Hume Coal Project and Berrima Rail Project

Submission to the Independent Planning Commission (SSD7172 and 7171)

J12055 RP#3

Figure 2.1 Hydraulic conductivity data considered during model development

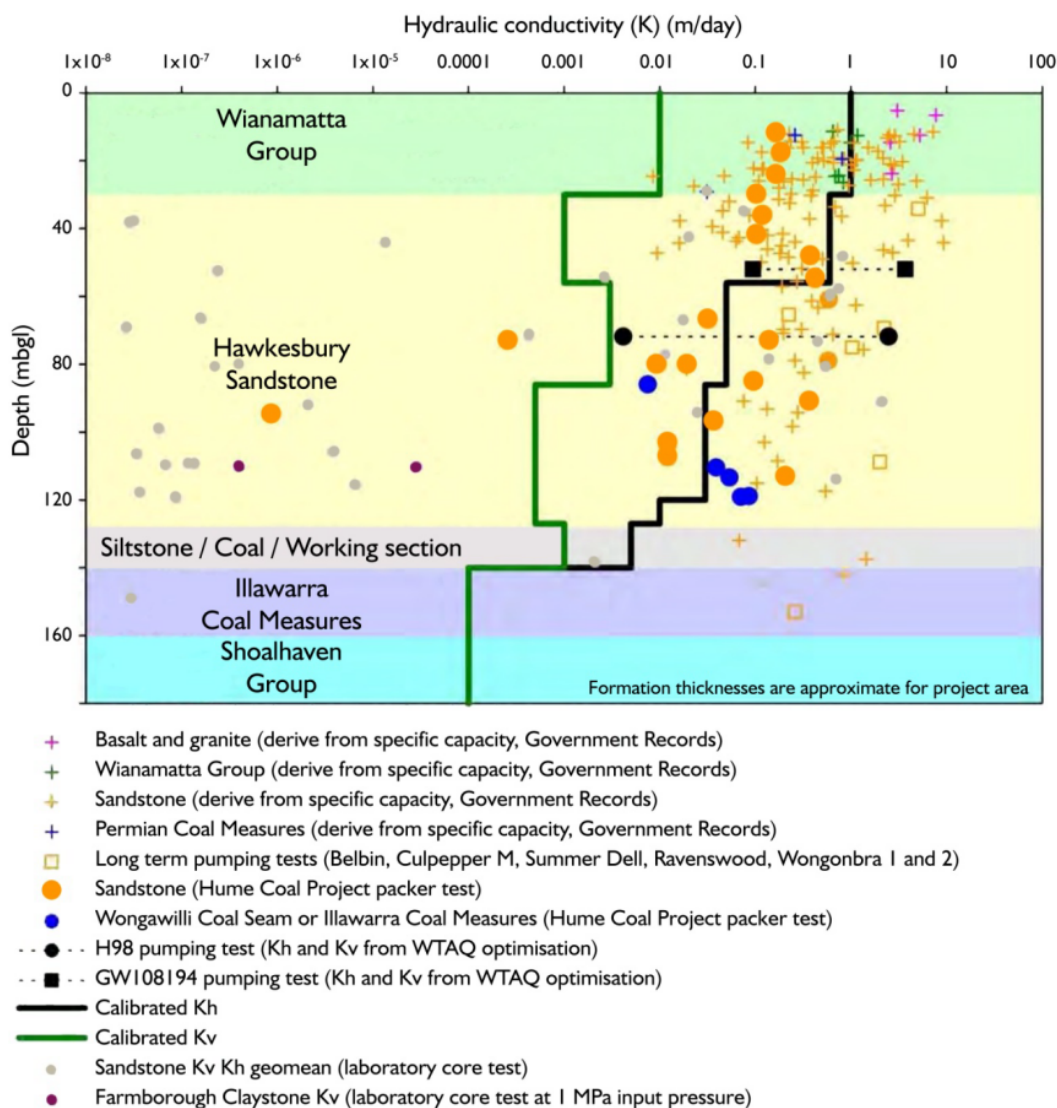
There is natural variation in testing methods, with pumping tests bias towards higher conductivities (due to bores used for pumping tests always being the highest yielding bores in the district ie those that intercepted localised fractures). Core permeability provides the lower end range of conductivity. Figure 2.1 below shows that all of this data was considered in developing the model. The model calibration was in line with best practice and considered all of this data and DPE’s expert states that:

Figure 2.2 Distance to 2 m drawdown in landholder bores

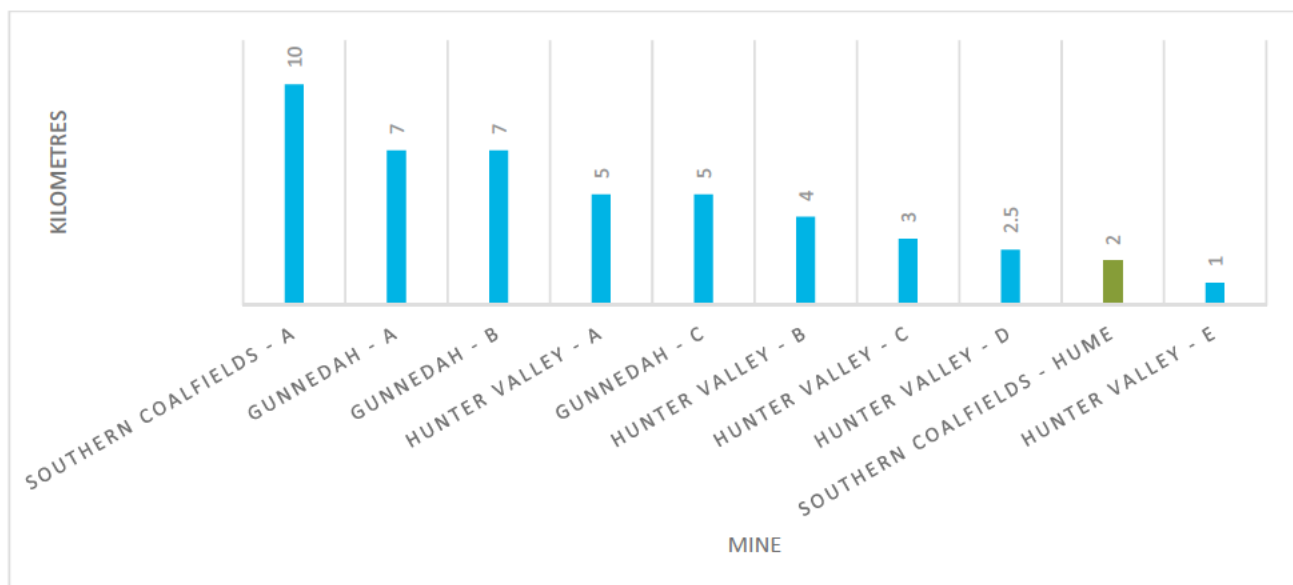
In the presentation by a DPE representative, Clay Preshaw, at the Public Hearing for the project on 26 February 2019, Clay clarified that the DPE claims of ‘unprecedented level of impact’ only applies to the number of bores impacted and not the level of environmental impact (ie drawdown or inflow).

The distance to the maximum 2 m drawdown contour (as required to be considered under the AIP) is tabulated for 11 mining projects in NSW, with the drawdown extent predicted for the project being 25% lower than the average drawdown predicted across these 11 projects (Figure 2.2).

Figure 2.8 Comparison of 67th %ile and 90th %ile

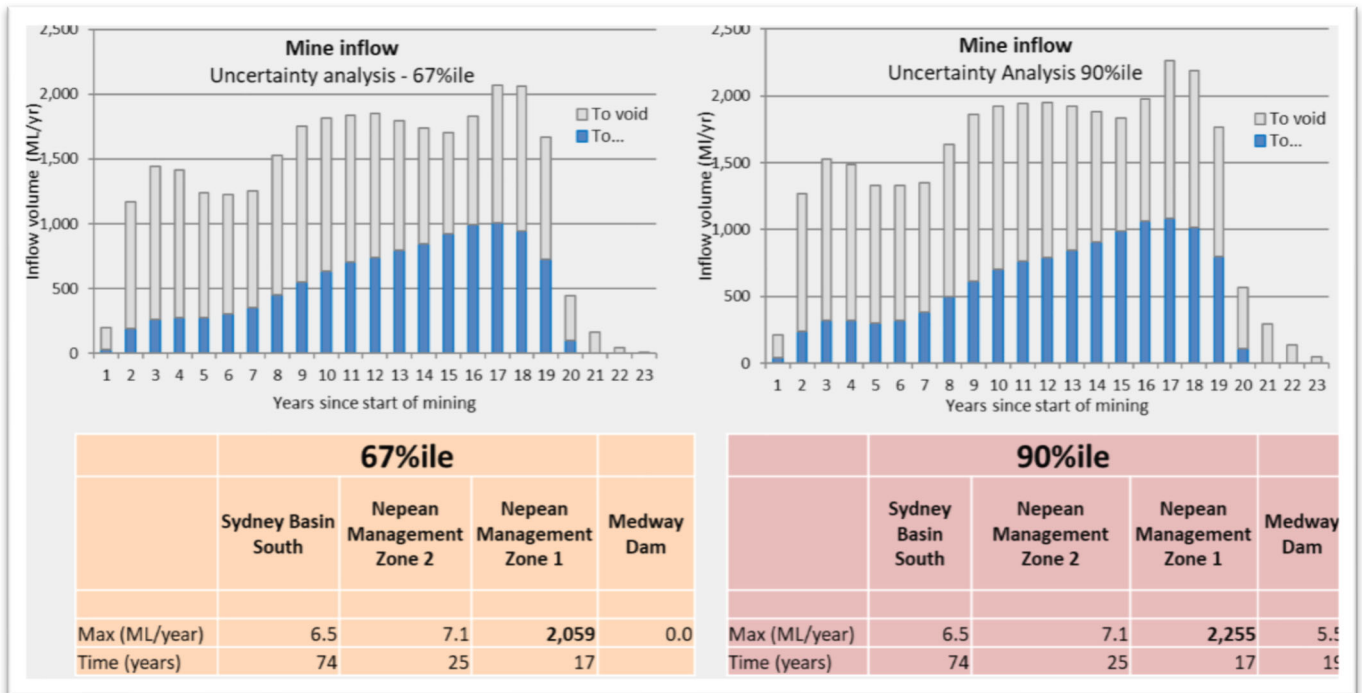
The DPE state that due to potential model uncertainty a more conservative approach to licensing should be adopted. However, Hume Coal dispute that the model results are uncertain based on the detailed modelling and uncertainty analysis undertaken. The model is deemed 'fit for purpose' by DPE's expert and therefore the adoption of 67thile should be retained. The decision on the licensing should also consider the conservative approach taken whereby both 'to void' and 'to sump' water is being licenced.

Figure 3.2 Hume Coal Site 3 – Vertical surface movement due to rainfall events

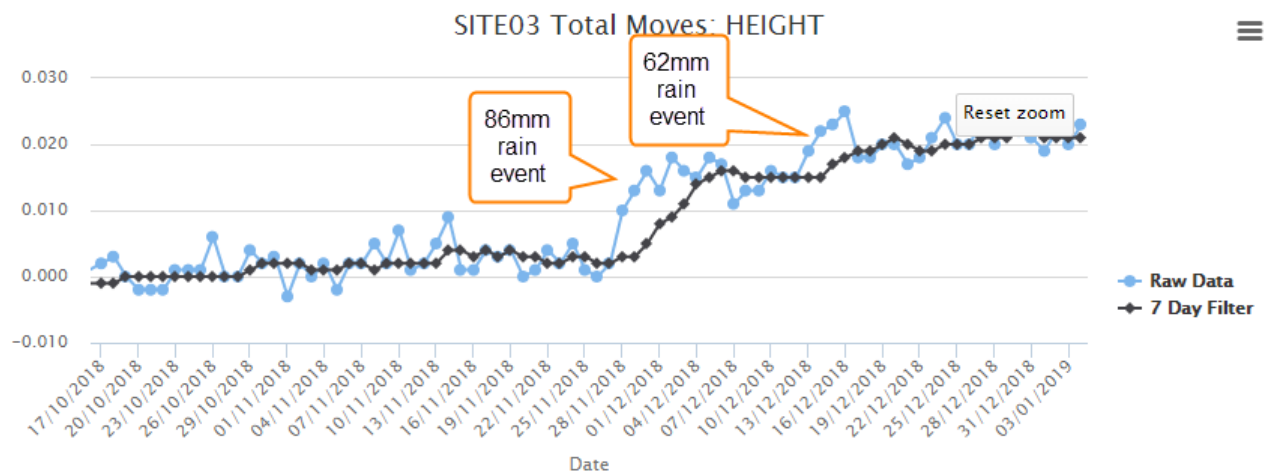
Section 5.4 [pg 15] - Subsidence Advisory NSW noted “the *predicted worst-case subsidence predictions and considered that subsidence is unlikely to result in any impacts to surface infrastructure*”.

This view is endorsed as appropriate and recognises that the proposed mining method is clearly minimalist in terms of surface impacts, when compared with other conventional underground mining systems of a similar level of extraction. Some additional useful information has recently been provided by Hume Coal based on current site surface subsidence monitoring stations. These confirm that the level of surface vertical movements due to natural climatic variation (rainfall or drought), with no mining present, can be of the order of at least 20 mm. Recent results from the Site 3 monitoring are shown in Figure 3.2.

FIGURE 3.4. Illustration of the Extreme Nature of the Numerical Model Calibration Point by Reference to International Subsidence Behaviour (GAPL 2018)

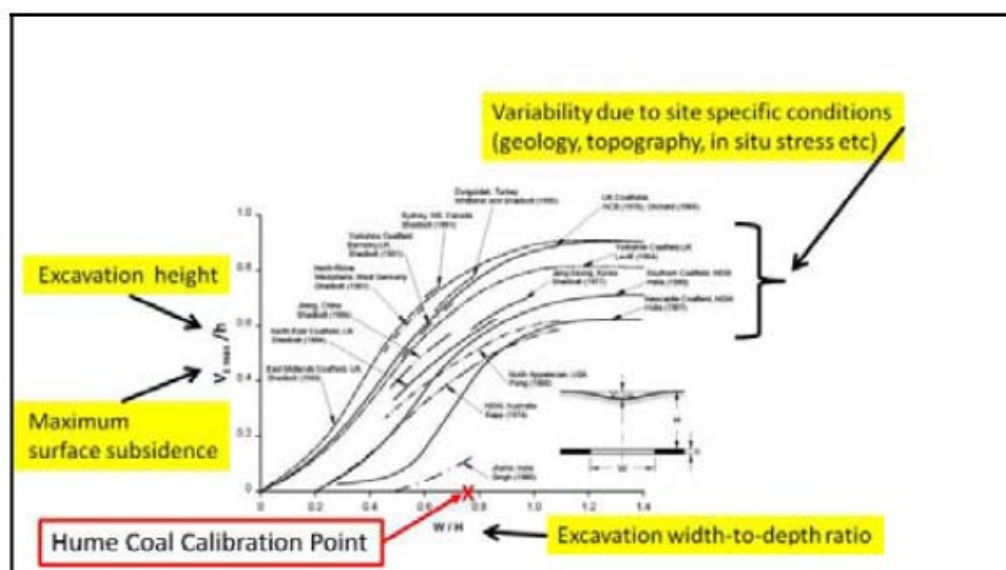
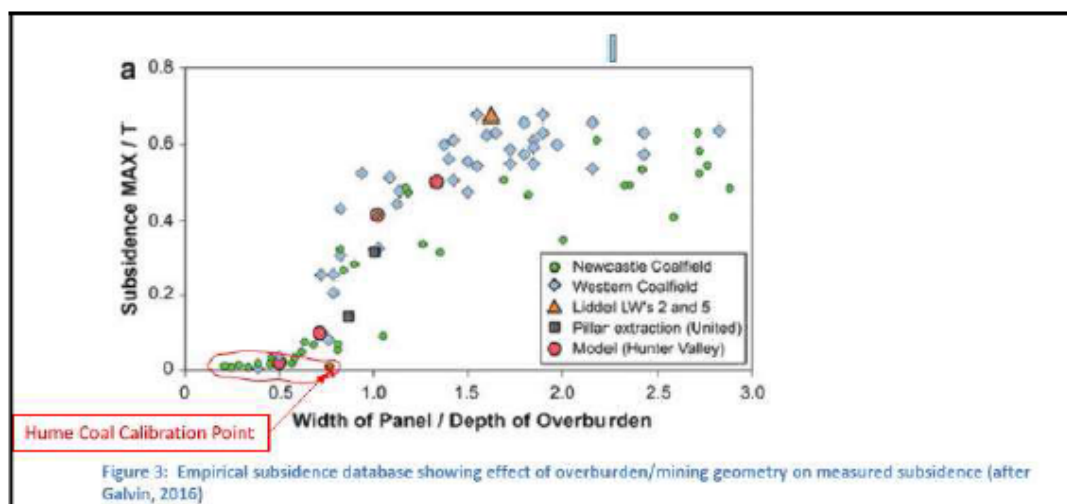
"The extreme nature of the negligible subsidence is illustrated by reference to Figure 1 and Figure 2 (Figure 2 is incorrectly attributed to Galvin). As another point of reference, GAPL calculated predicted surface subsidence using the methodology and material values presented in the Hume Coal EIS. This approach predicts a surface subsidence of about 130 mm for the given dimensions".

GAPL 2018 refers to two figures (reproduced herein as Figures 3.4 and 3.5) in explaining the basis of the concern raised. These will be referred to as required in formulating this response.

If it is accepted for the sake of argument that surface subsidence above SW1 panel is not being significantly influenced by remnant coal in areas of attempted full extraction, the question then remains as to whether there are other reasons as to why the magnitude of S_{\max} being < 10 mm is extremely low, as compared to comparable extraction panels, this being clearly indicated by the reviewer based on **Figures 3.4 and 3.5**.
